123 DC - 195 Duncan Creek Rd., Lillington, NC 27546

PLAN 1 The Clayton - LH 'FRENCH COUNTRY' ELEVATION

10-22-24- Redlines - JJ

THE CLAYTON - LH
Cover Sheet 'French Country'

RIGHT SIDE ELEVATION 'FRENCH COUNTRY' (CRAWL/STEM WALL)
 SCALE: 1/8"=1'-0" ON 11x17, 1/4"=1'-0" ON 22x34
 SEE FOUNDATION PAGES FOR FOUNDATION TYPE

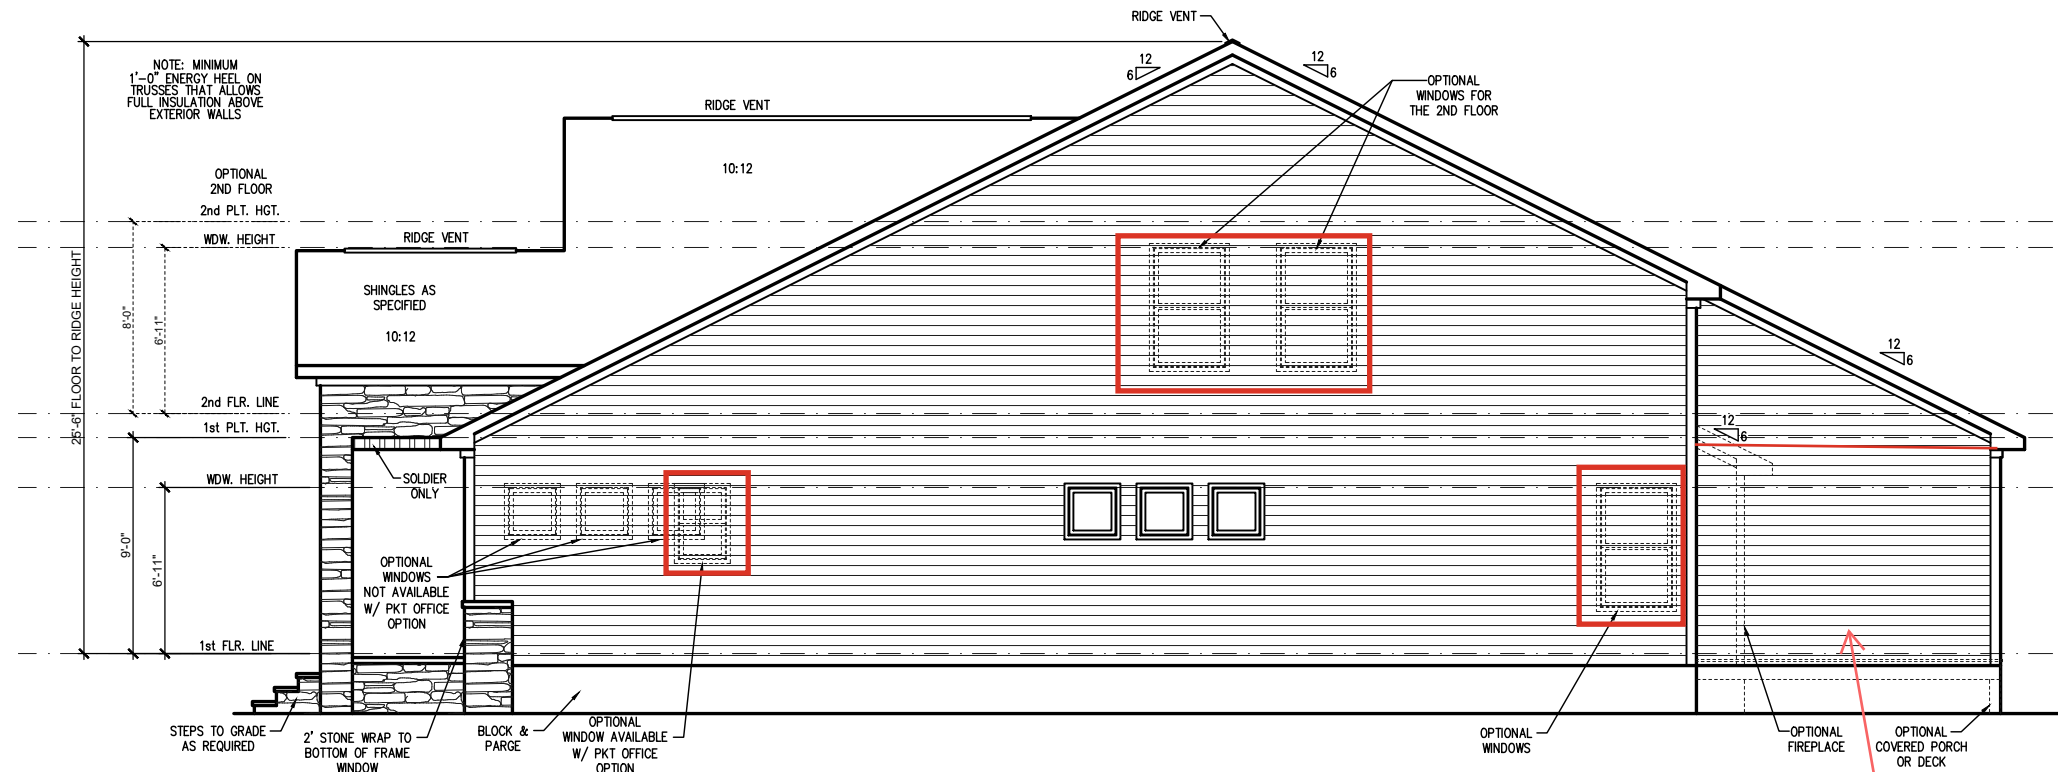
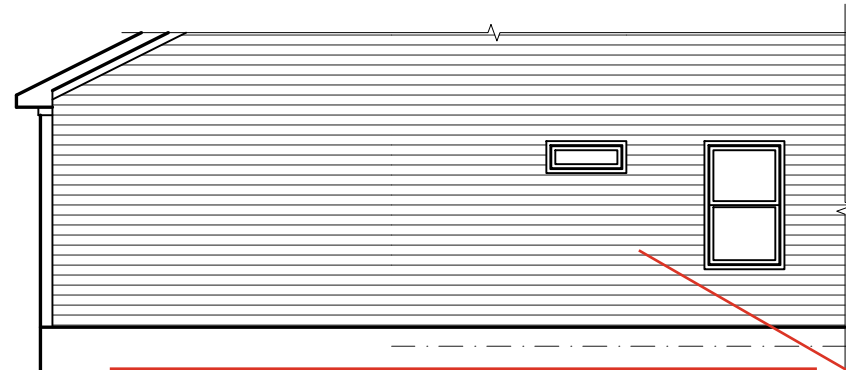
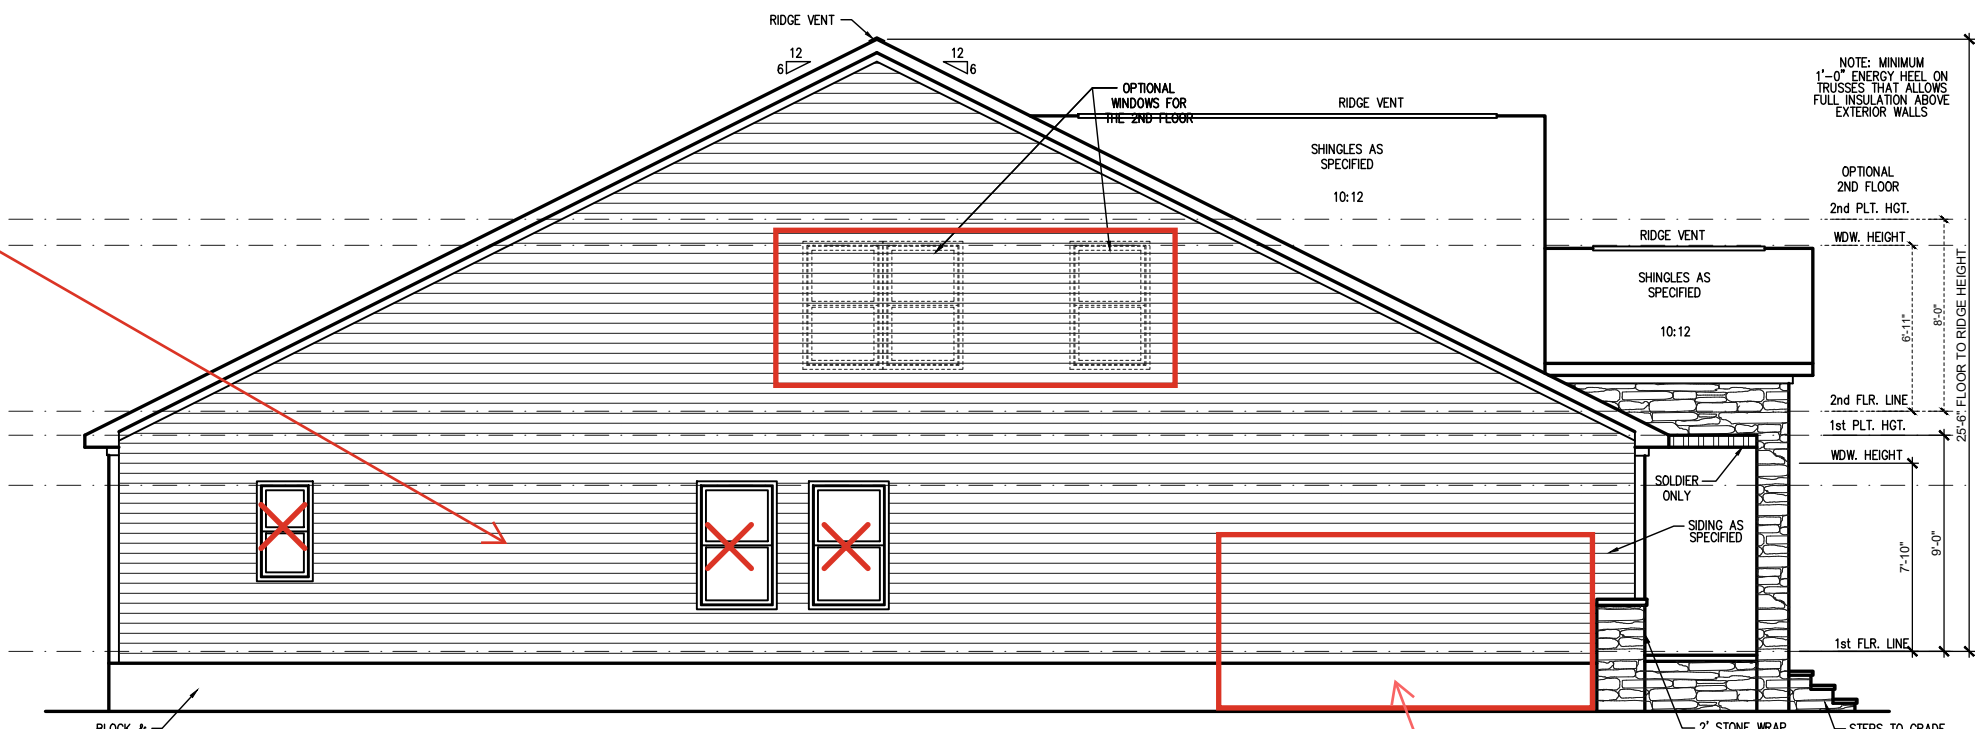
2.4.1b - covered porch

SCALE:
 1/8" = 1'-0"
 SHEET
3.4b

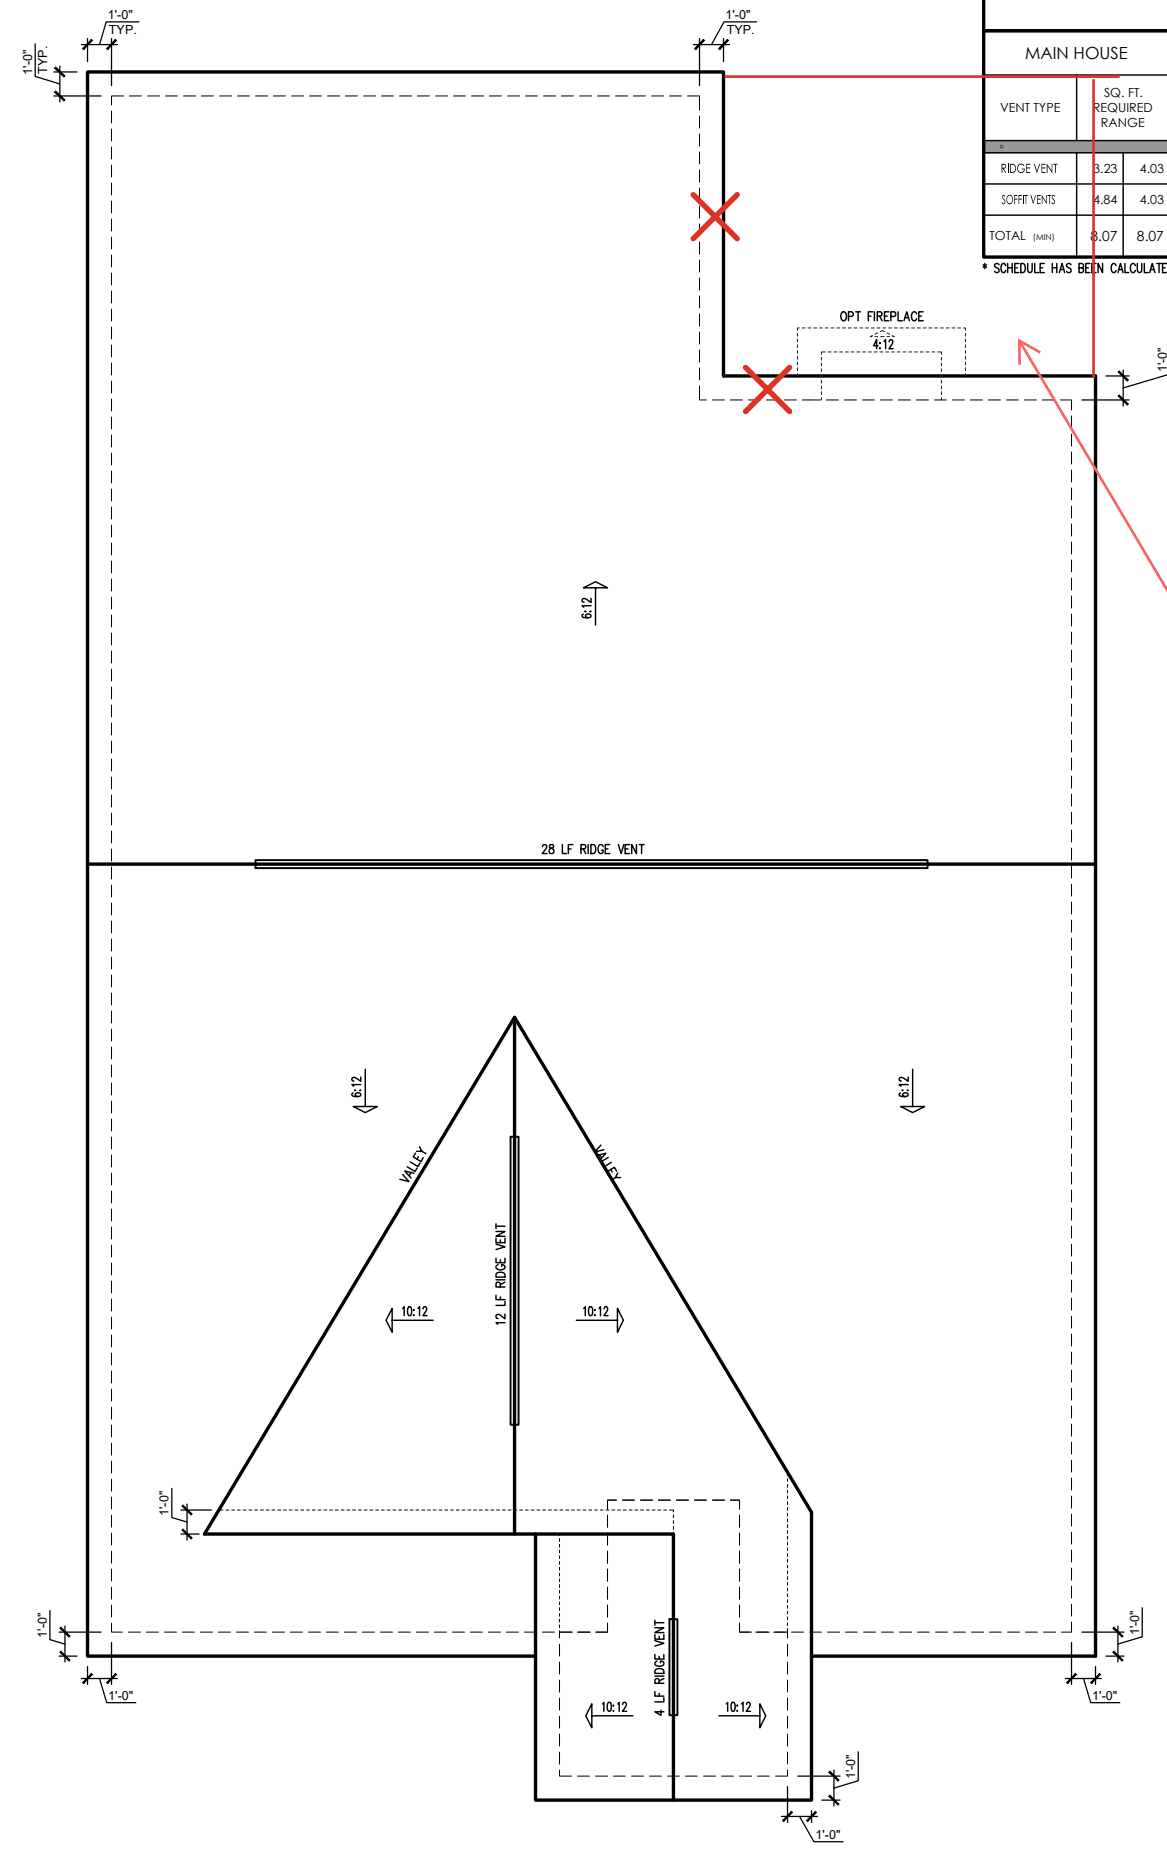
2.4.1b - covered porch

OPT. 3-CAR GARAGE
'FRENCH COUNTRY' ROOF PLAN

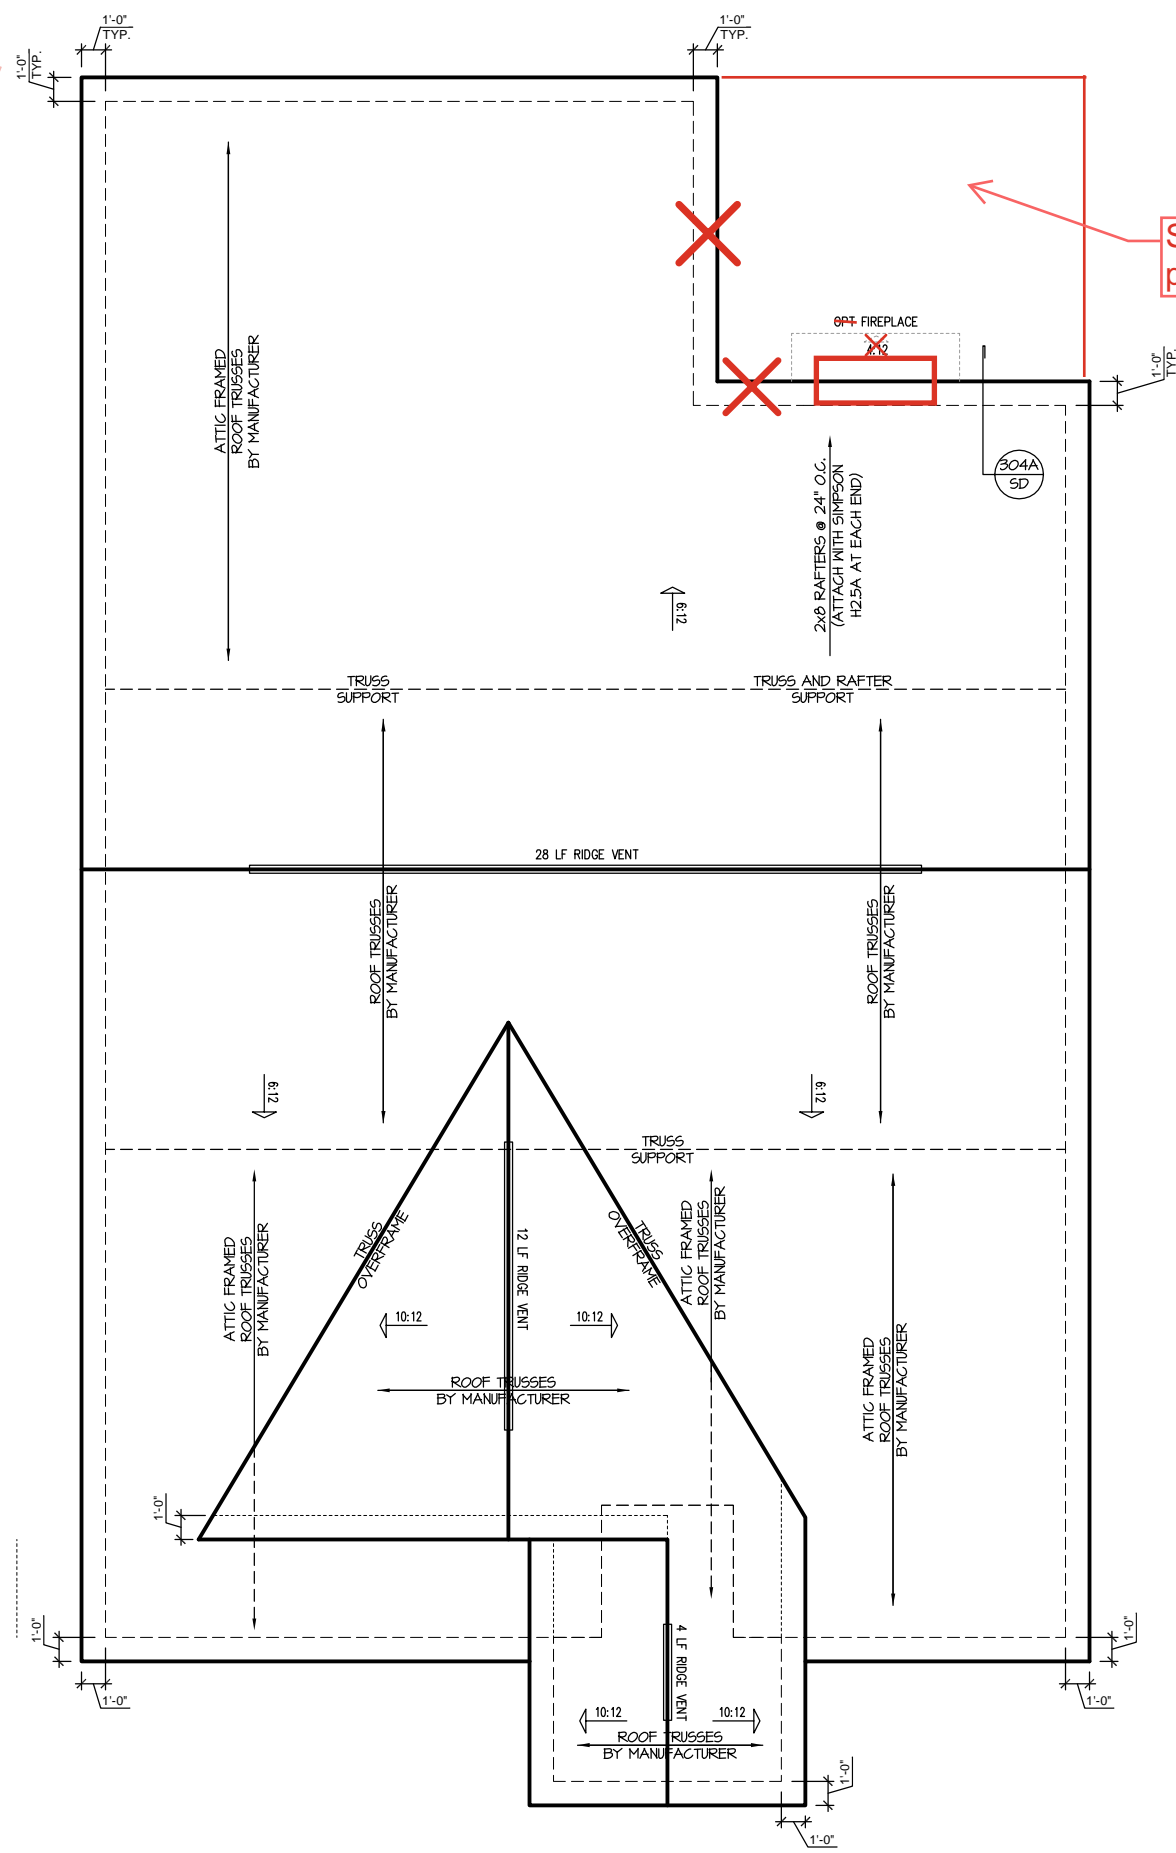
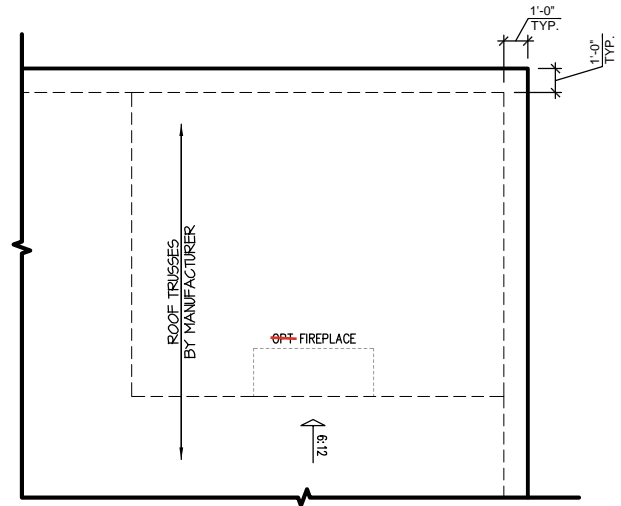
S-2.3 - covered porch
